SOLICITATION ADDENDUM NO. 2

Project Title	Date Prepared	Project No.
SJCCD Maritime Expansion Fire Training Center	December 4, 2019	CSP 20-12

ADDENDUM NO. 02

Project: **Maritime Expansion Fire Training Center**
 San Jacinto Community College District

EXTERIOR
 ELEVATIONS

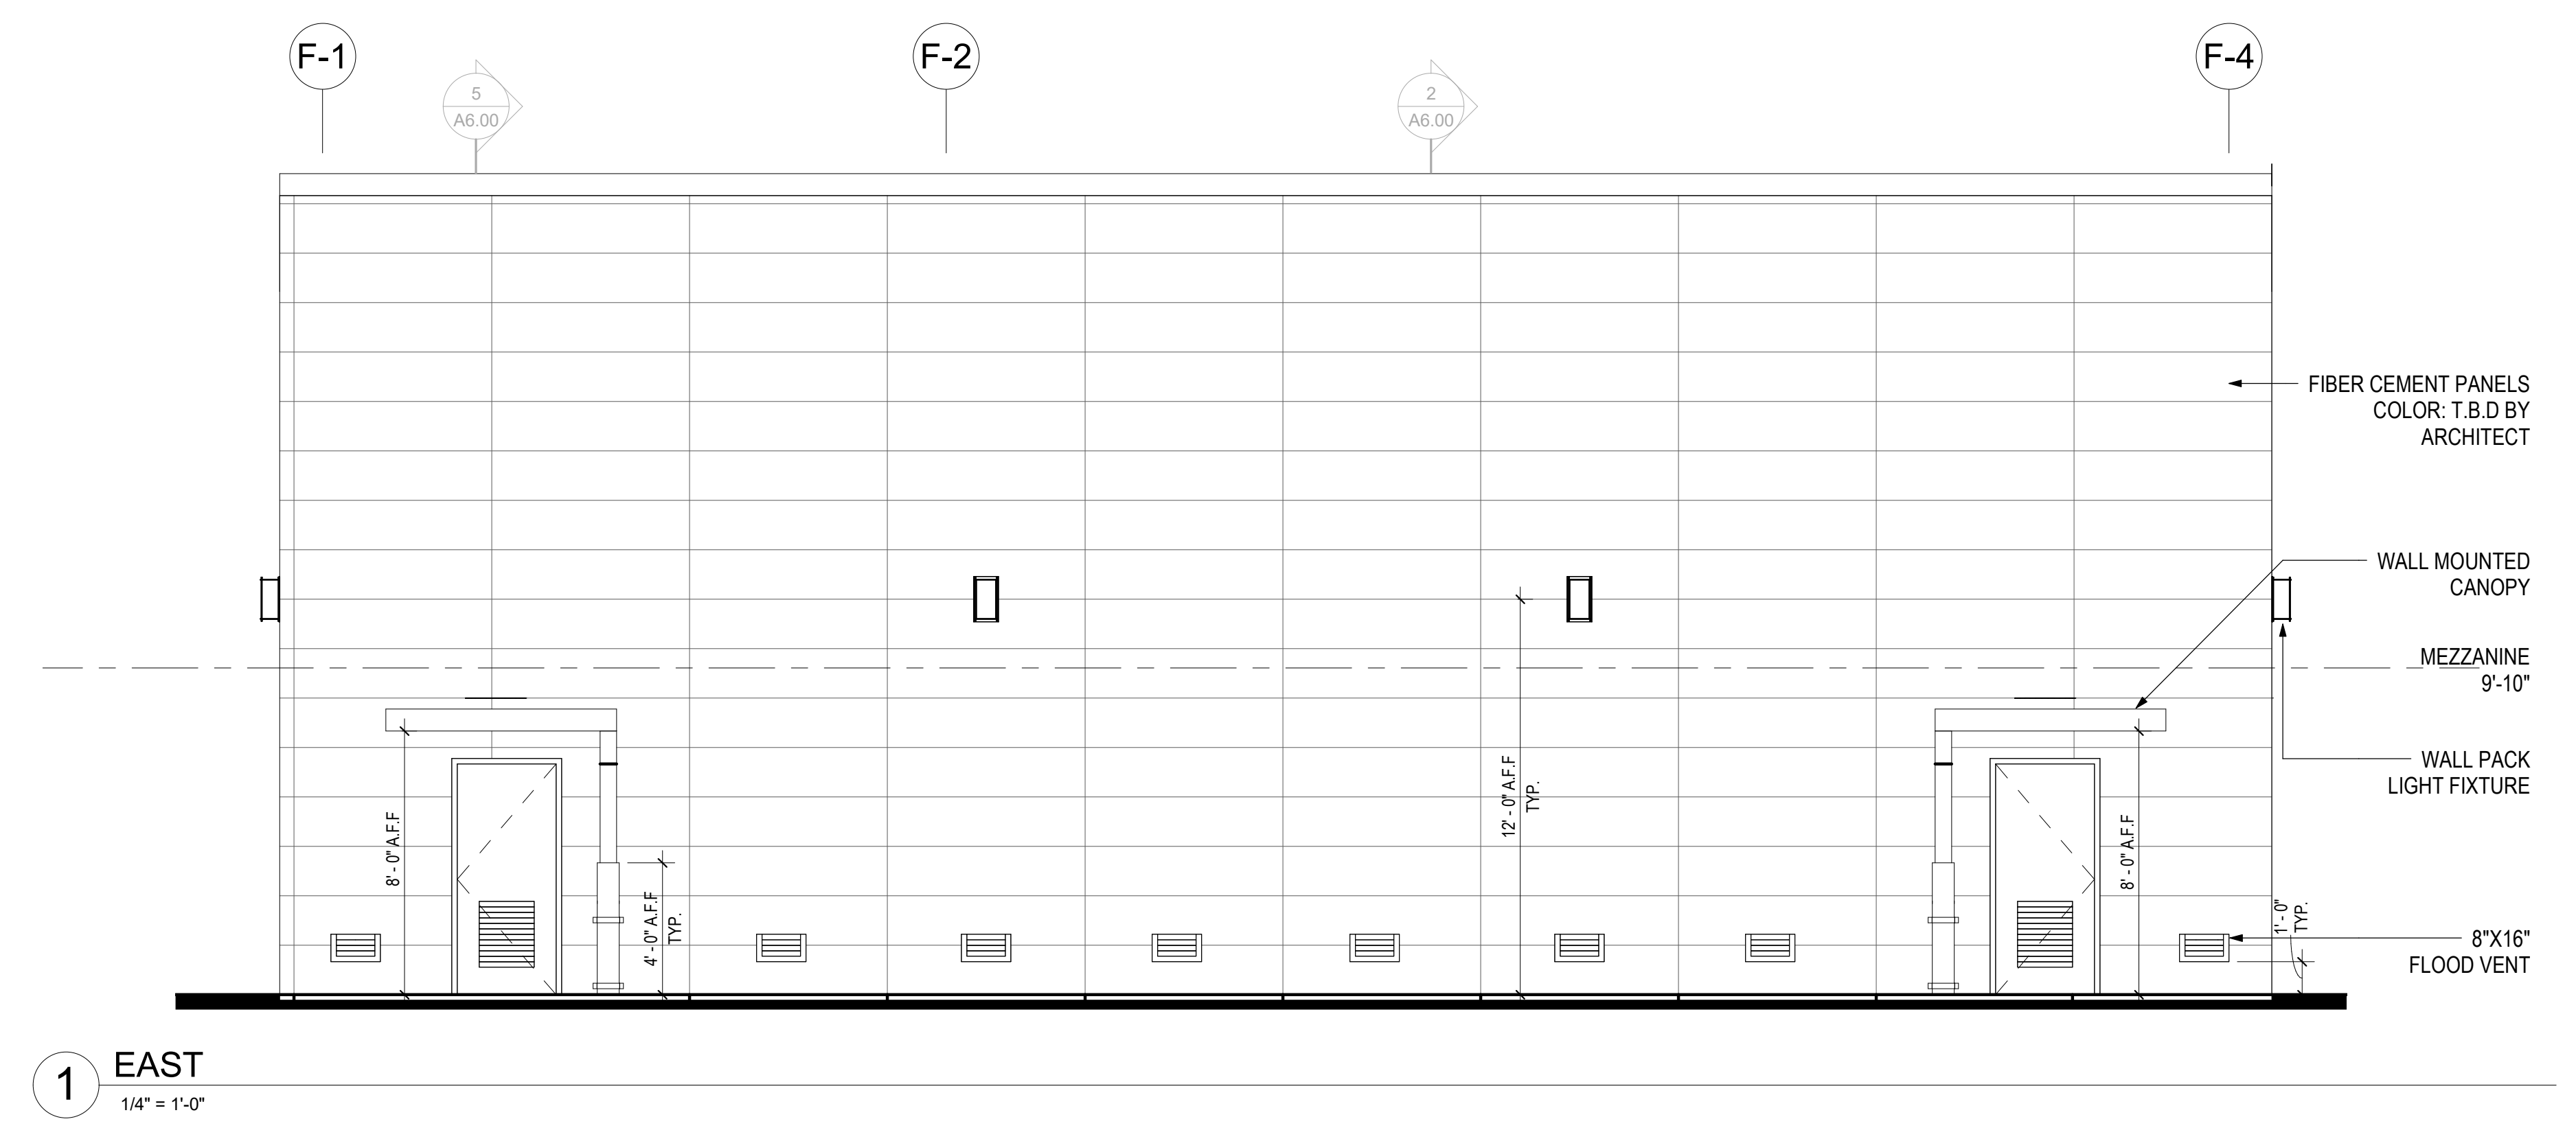
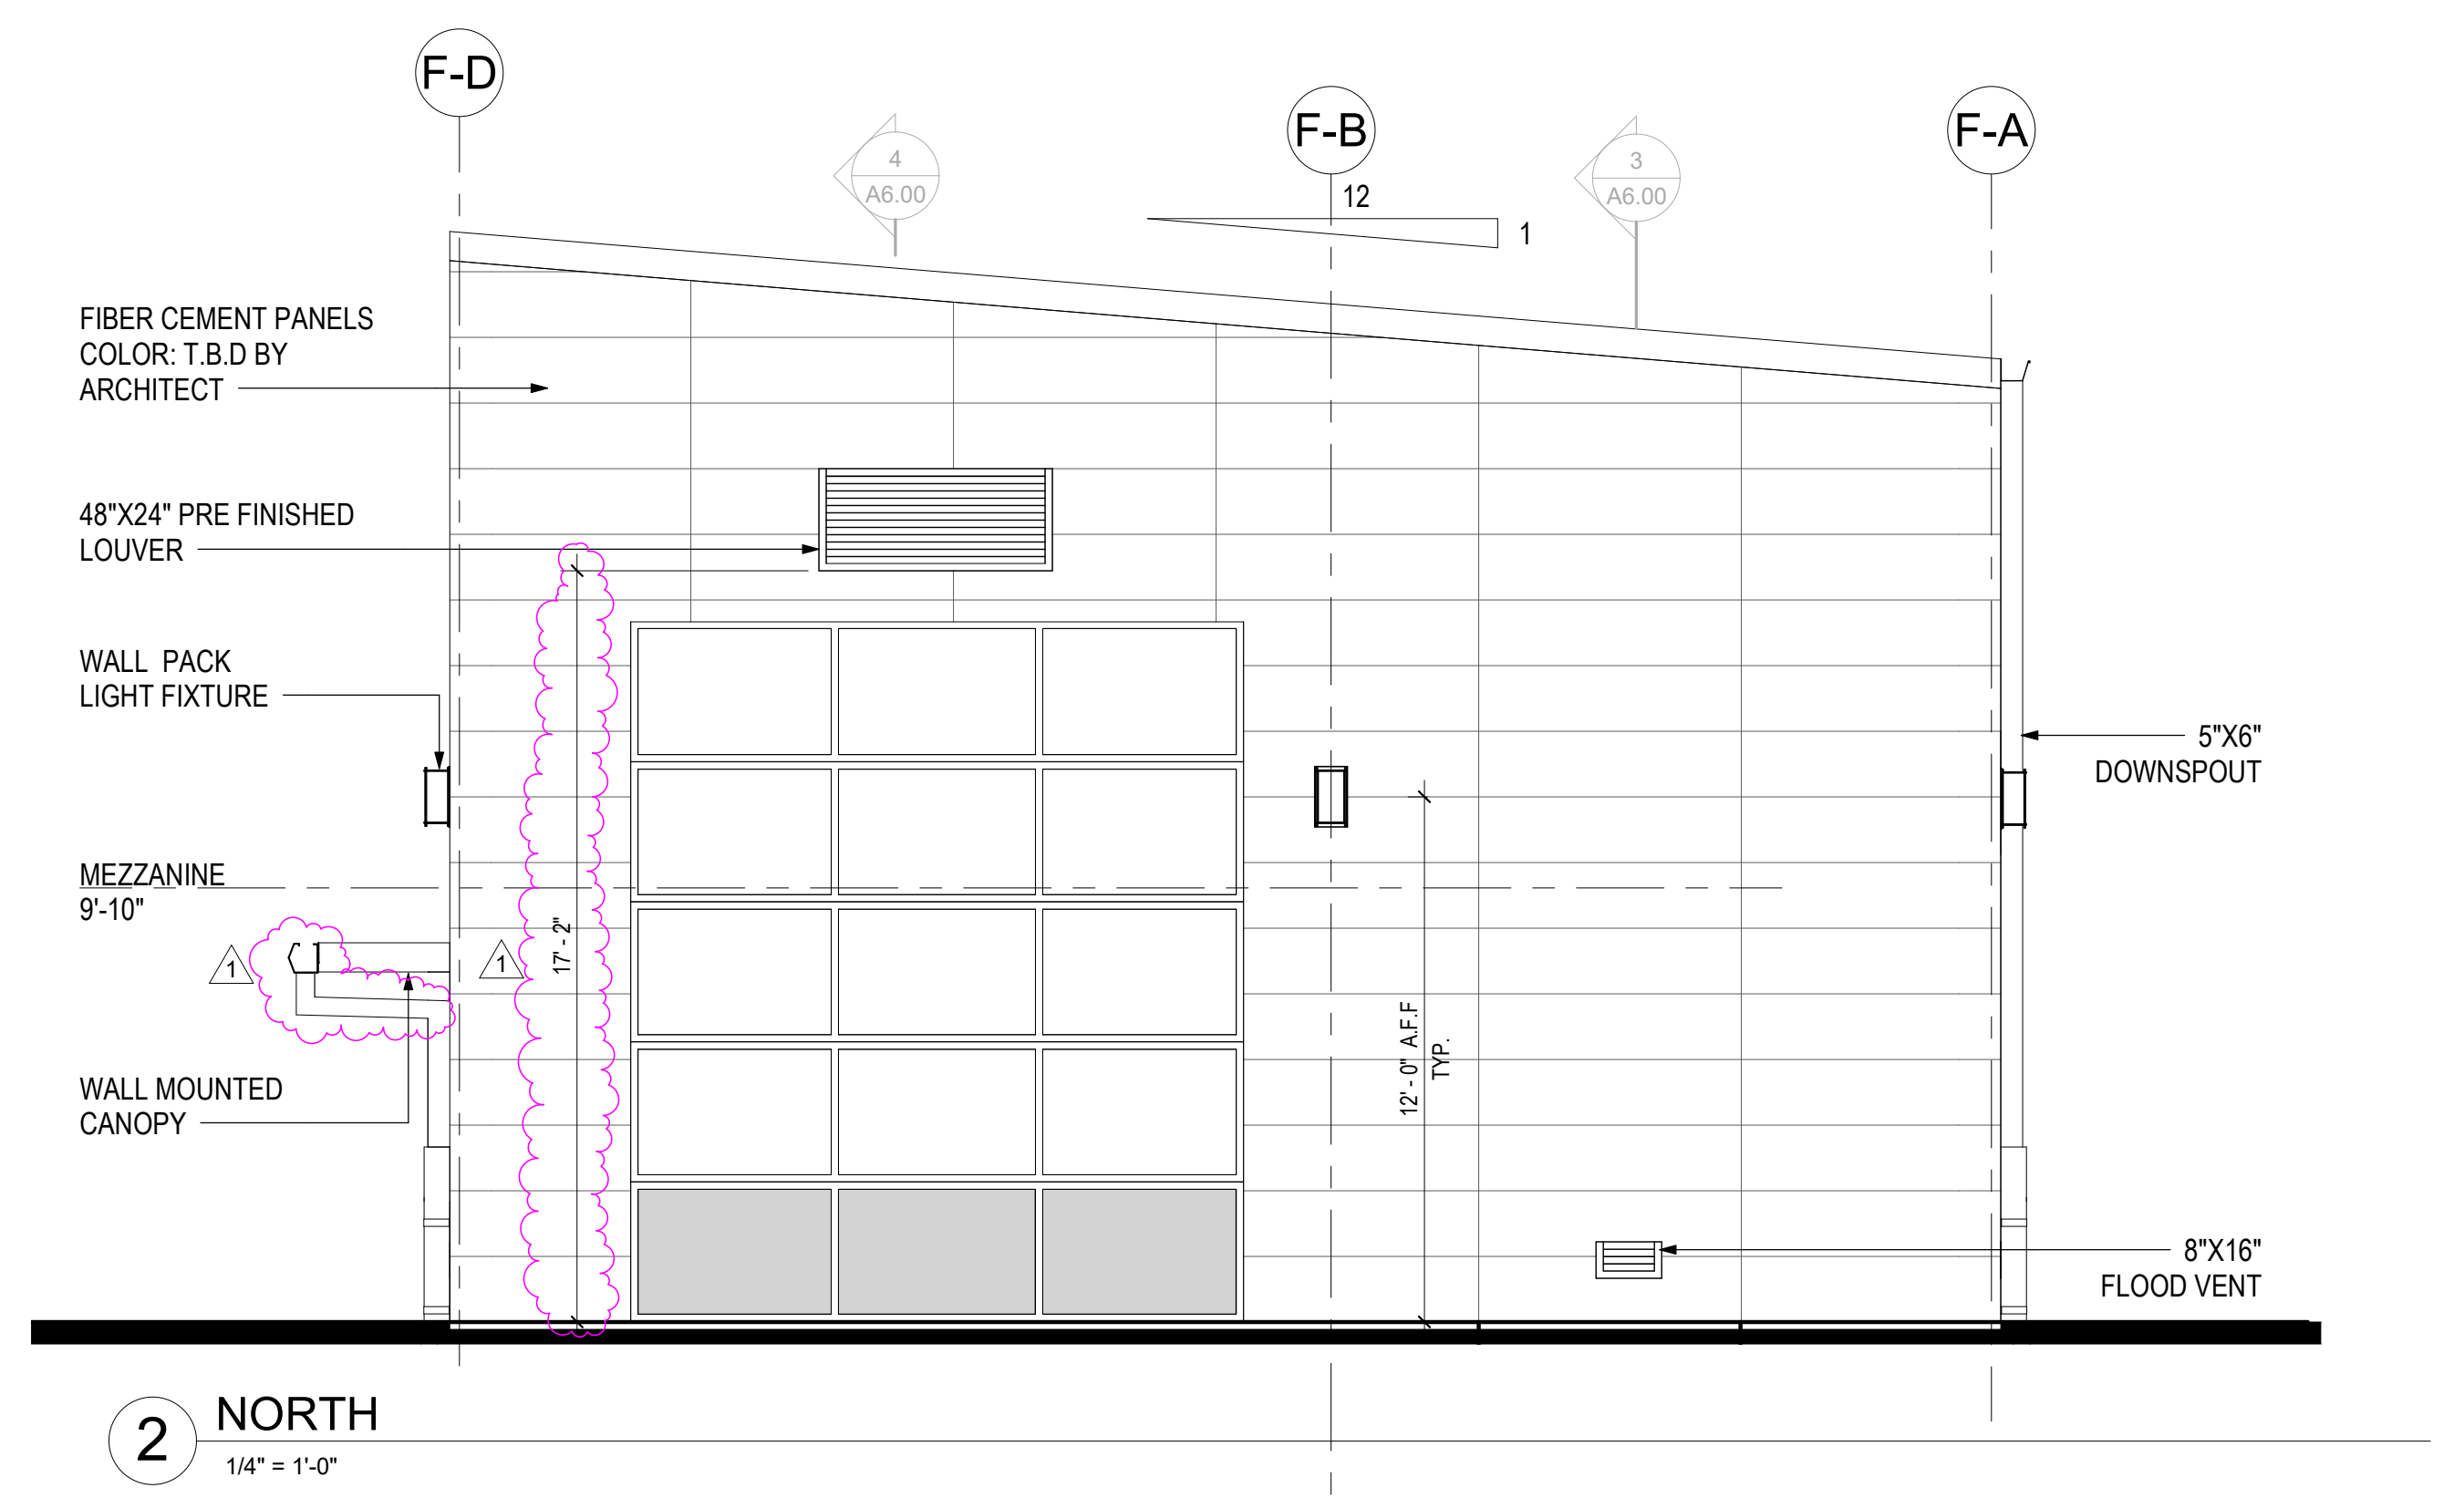
20. Sheet A7.01 – Exterior Elevations
 - a. On details, 2 and 4 the louvers heights were adjusted.
 - b. On details, 2 and 4 the downspout is revised to match detail 7/6.00.
 - c. An Additional louver has been added on detail 3.
